REQUEST FOR COMMITTEE ACTION

HENDERSON COUNTY TECHNICAL REVIEW COMMITTEE

SUBJECT: Master and Phase I& Phase IA Development Plan for the Boulders of

Hendersonville Subdivision (2012-M01)

Map A: CCP Future Land Use Map

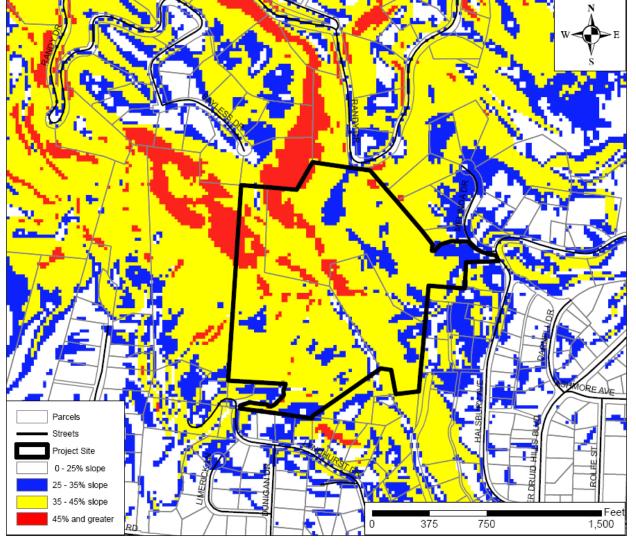
- 1. **Henderson County 2020 Comprehensive Plan (CCP).** The Future Land Use Map of the CCP shows the project site as being located within each of the following areas: Conservation Area and Urban Services Area (USA) (See Map A: CCP Future Land Use Map).
 - (a) **Conservation Area.** The conservation area designation is applied to a majority of the project site, largely due to slope and a protected mountain ridge (See Map A: CCP Future Land Use Map, Map B: Slopes Map, and Map C: Protected Ridges). The overwhelming majority of slopes within the project site appear to be in excess of 25 percent, with portions having slopes in excess of 60 percent. According to the plan, only a minority of the steep slope areas within the project site appear to be located in designated common area/open space. The CCP states that conservation lands "are

intended to remain largely in their natural state, with only limited development," and further that "such areas should be targeted for protection through regulations and incentives" (2020 CCP, Pg. 134). Lots which contain slopes in excess of 60 percent include the following 21lots: C9, C10, C11, C5, C6, P1, P2, P12, P10, P8, W3, W8, W11, E1, E2, E3, E4, E5, E6, E7, E8 (See Attachment 4,Master Plan). Should the Technical Review Committee wish to recommend approval of the Revised Master Plan, Planning Staff recommends that, where possible, the applicant reconfigure lots and alter the design of the development so that slopes in excess of 60 percent remain in common area/open space.

Map C: Protected Mountain Ridges Map

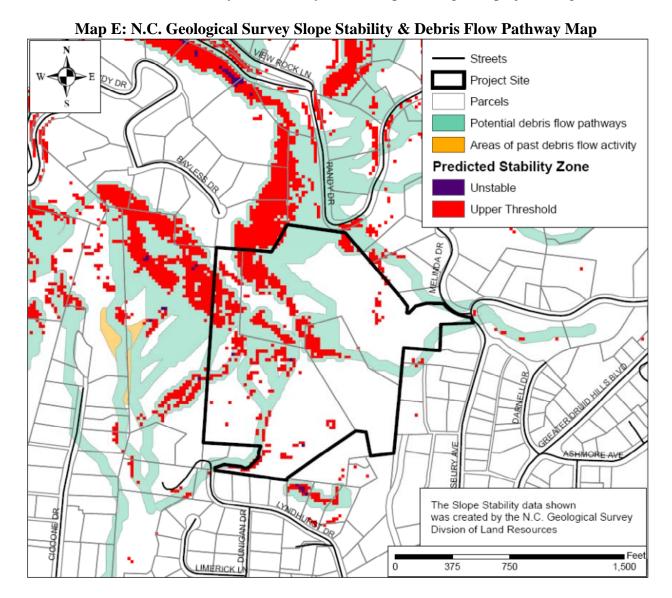
2. **Protected Mountain Ridges**. The project site appears to contain an area effected by the Mountain Ridge Protection Ordinance which states that the provisions of NCGS 113A-209 apply to all mountain ridges in Henderson County whose elevation is 500 feet or more above the adjacent valley floor (Map C: Protected Mountain Ridges). NCGS 113A-209 states that no county may authorize the construction of, and no person may construct, a tall building or structure on any protected mountain ridge. The definition of a tall building found in NCGS

113A-206 is any building with a vertical height of more than 40 feet measured from the top of the foundation and the uppermost point of the building. Additionally, where such foundation measured from the natural finished grade of the crest or the natural finished grade of the high side slope of a ridge exceeds three (3) feet, then such measurement in excess of three (3) feet shall be included in the 40-foot limitation provided that no such building protrudes at its uppermost point above the crest of the ridge by more than 35 feet. The area of ridge under protection is defined as the elongated crest or series of crests at the apex or uppermost point of intersection between two (2) opposite slopes or sides of a mountain, and includes all land 100 feet below the elevation of any portion of such line or surface along the crest. Planning Staff recommends, as a condition of approval, that the Applicant shall adhere to the Mountain Ridge Protection regulations of the County which state that the provisions of NCGS 113A-209 apply to all mountain ridges whose elevation is 500 feet or more above the adjacent valley floor. Planning staff also recommends that the applicant be required to delineate the protected ridge area on the development plan(s) showing the area within 100 feet below the crest(s).

Map D: Official Zoning Map

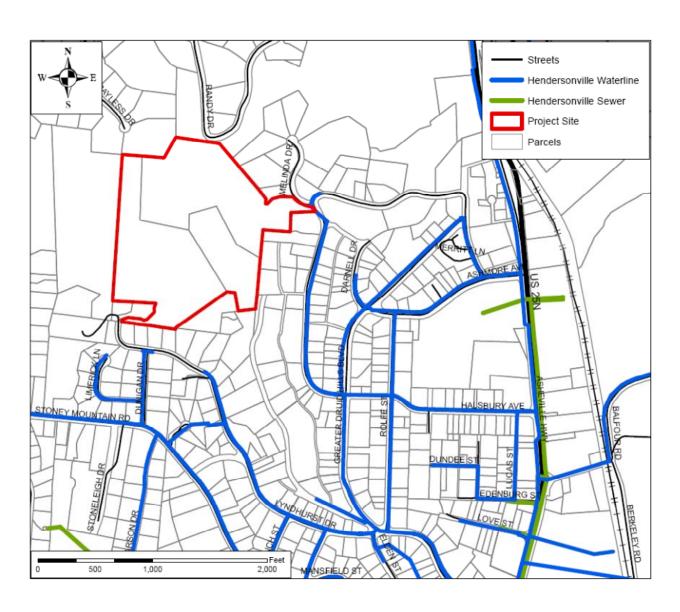
3. Chapter 200A, Henderson County Land Development Code (LDC). According to Chapter 200A, Henderson County Land Development Code (LDC) and its Official Zoning Map adopted September 19, 2007 (as amended), the proposed project site is located within the Residential One (R1) (See Map D:Official Zoning Map). The R1 district allows for single-family residential development.

Combined, tracts 1, 2, & 3 includes 41.7 acres. R1 allows for a standard residential density of 4 units per acre where the slope is less than 60 percent. At total of 34.9 acres are in this category, meaning 139 units would be permitted within this acreage. Where slopes are 60 percent or greater, the density shall be one-half(½) of the eligible density (2 units per acre). A total of 6.8 acres of the project site are in this category, meaning a total of 13 units would be permitted. Therefore, the LDC allows for a maximum of 153 units on the project site. The Master Plan proposal of 59 units would fall within the density permitted by the LDC.

The eastern portion of tract 1 is within the City of Hendersonville's Extra Territorial Jurisdiction (ETJ). According to the submitted Master Plan no lots or units are proposed within this area.
